AGENDA
Historic Yorktown Design Committee

SUBJECT: Application No. HYDC-254-24; Yorktown Apartments

DATE: July 11, 2024 (HYDC Mtg. 7/17/24)
TO: Historic Yorktown Design Committee
FROM: Jeanne Sgroi, Senior Planner
SUBJECT: Application No. HYDC-256-24; Coastal Thirst, LLC

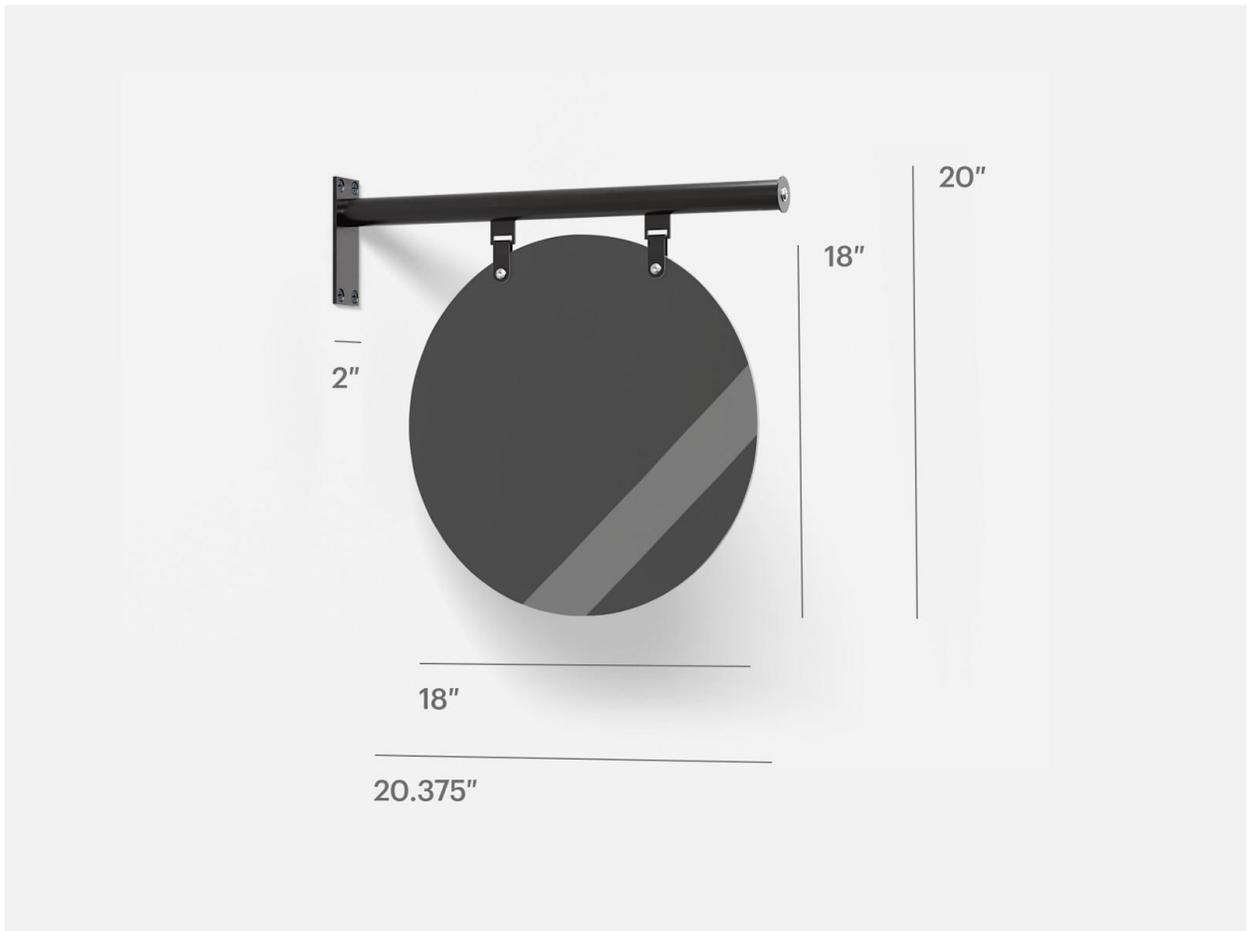
<p><u>2. Location</u></p> <p>c. Hanging signs should be attached to the underside of the porch roof or lintel, parallel to the front of the building, or from a bracket perpendicular to the face of the building or a porch column. Hanging signs should not be located higher than the top of the porch.</p>	<p>The sign would be attached from a bracket perpendicular to the face of the building. It would not be located higher than the top of the porch.</p>
<p><u>3. Design, Shape and Materials</u></p> <p>a. Sign design should be compatible with the character of the building and simple in background, colors, lettering, and mounting structure. The building should remain the dominant feature, not the sign.</p> <p>b. A horizontal layout should be used for hanging signs. Signs hung over porch stairs or entrances should have a minimum clearance of seven feet six inches (7'-6").</p> <p>d. Signs should be constructed of appropriate but durable materials, such as:</p> <ul style="list-style-type: none">(1) marine-grade exterior plywood or weather resistant composite materials, with banded or sealed edges, and all elements primed and painted.(2) brass or bronze sign panels attached to front façade, fence, or wall(3) painted iron or pressure-treated wood posts for freestanding posts.	<p>Staff believes the proposed sign is compatible with the character of the building and simple in background, colors, lettering, and mounting structure. The building, and not the sign, would remain the dominant feature.</p> <p>The sign would have a circular, not horizontal layout. The sign is not proposed to hang over porch stairs or entrances. The proposed sign does not fully meet the Guideline recommendation because of its circular layout.</p> <p>The sign would be constructed from a ¼" thick weather-resistant aluminum. The proposed sign does not meet this Guideline recommendation.</p>

The proposed door color fits within the Design Guidelines recommendations. While the proposed sign features four colors, rather than the three specified in the Guidelines, staff

believes the dominant colors are cream, black, and aqua. The sign would be circular. Though the Guidelines recommend a horizontal layout, most of the text is displayed horizontally and is easy to read. Most of the colors appear to be selected from the Yorktown Color Palette with the exception of the aqua. Furthermore, the sign would be constructed of weather-resistant aluminum, rather than marine-grade exterior plywood or weather resistant composite materials. However, the proposed sign is properly sized, with appropriate hardware, and would be located in a recommended location. The sign does not advertise products, or feature a thematic design, or internal illumination. While the sign does indicate that the business is a delicatessen, staff believes this design element is necessary and not a dominant feature. Because the most prominent colors of the proposed sign are cream and black, while the building is also painted cream and black, staff believe the sign is compatible with the character of the building. Due to its simple design, small size, compatibility with the character of the building, and consistency with the remaining Guidelines, staff believes the sign is appropriate.

- 1) The sign design and features shall be consistent with the conceptual renderings entitled “Coastal Thirst Beach Deli Sign” and “Sign Proposal”, and dated June 24, 2024.
- 2) If illumination of the signs is desired in the future, ground-mounted fixtures that are low-intensity, and narrowly focused shall be approved by the Zoning Administrator prior to their installation.
